CHAPTER III

CHAPTER IV

Comments on the Draft EIR and Responses to Comments

Subject: Lawrence Berkeley National Laboratory 2006 Long Range
Development Plan & Draft Environmental Impact Report

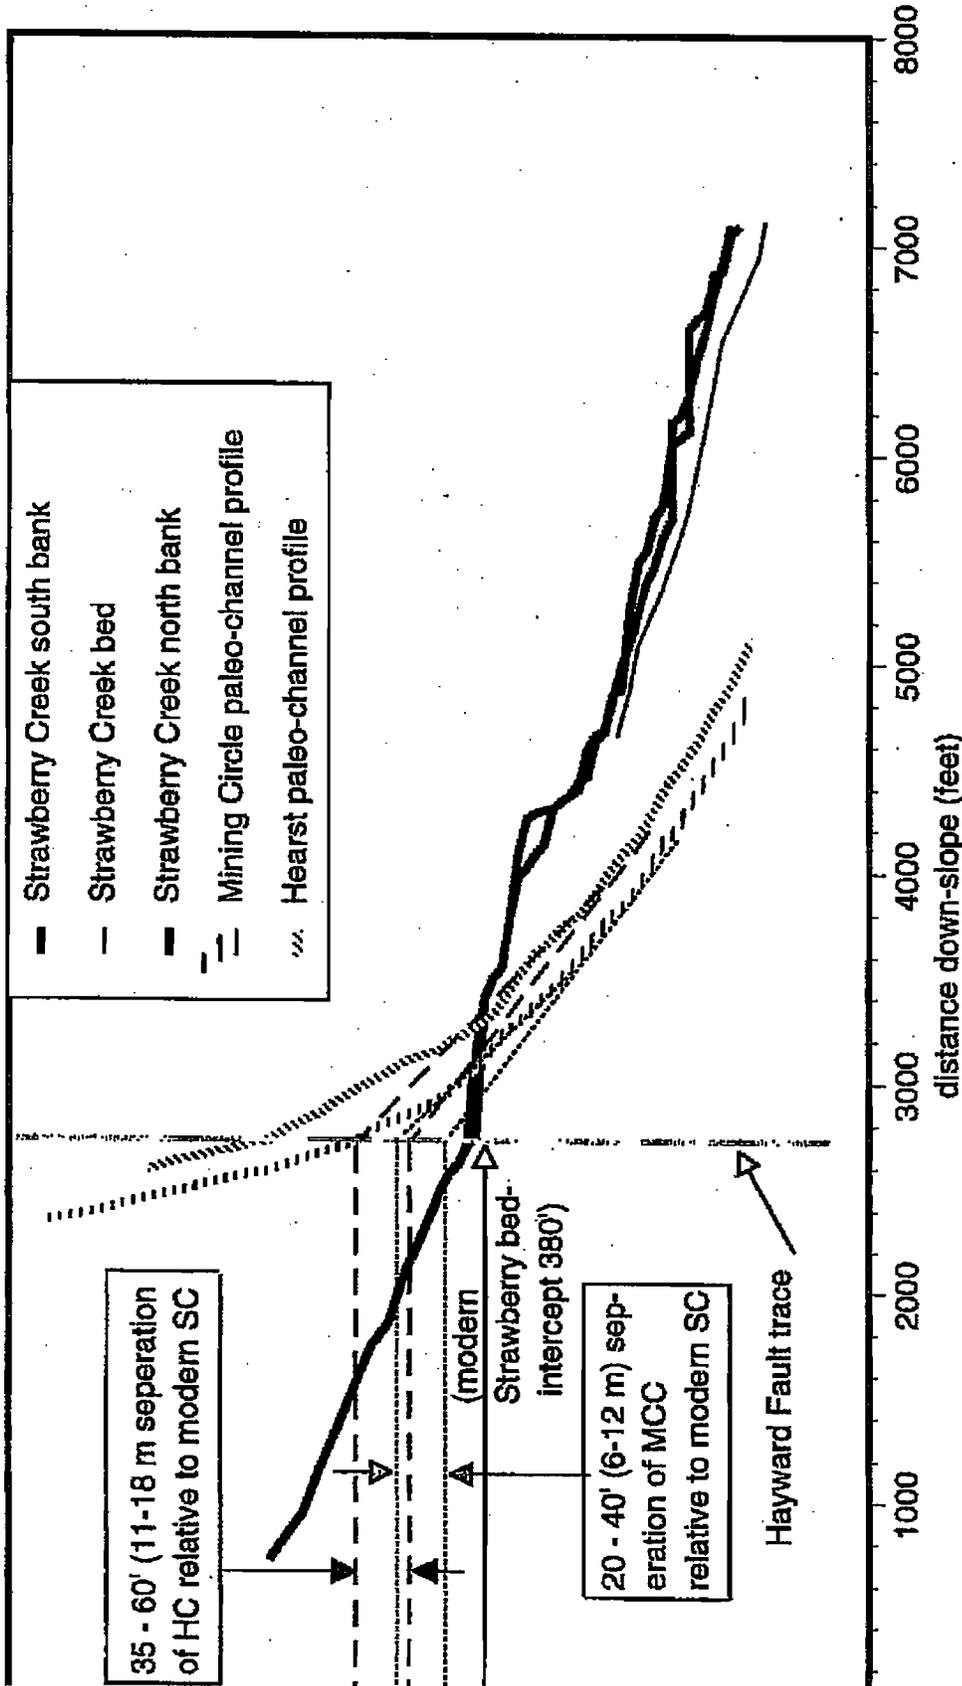
Channel and Bank Profiles are illustrated in [Figure 4](#). The active and beheaded channels of Strawberry Creek are aligned along the Hayward Fault. Ranges of vertical separation across the fault are noted graphically. Indicated are at least 10 but no more than 18 m of uplift of the Mining Circle channel. Also indicated are at least 12 but no more than 30 meters of Hearst channel uplift. Flattening of the active Strawberry Creek profile below the fault, along the length of the shutter ridge, results from tectonic lengthening of the channel by fault offset, and consequent alluviation. A "falls" occurred at the northern end of the shutter ridge. The much greater steepness of the paleochannels is attributed to control by much lower glacial base levels. The Strawberry profile is believed to have been greatly shallowed by aggradation as base-level rose. The much wider morphology of the modern stream valley that is apparent in [Figure 3](#) is indicative of alluviation of the glacial era valley.
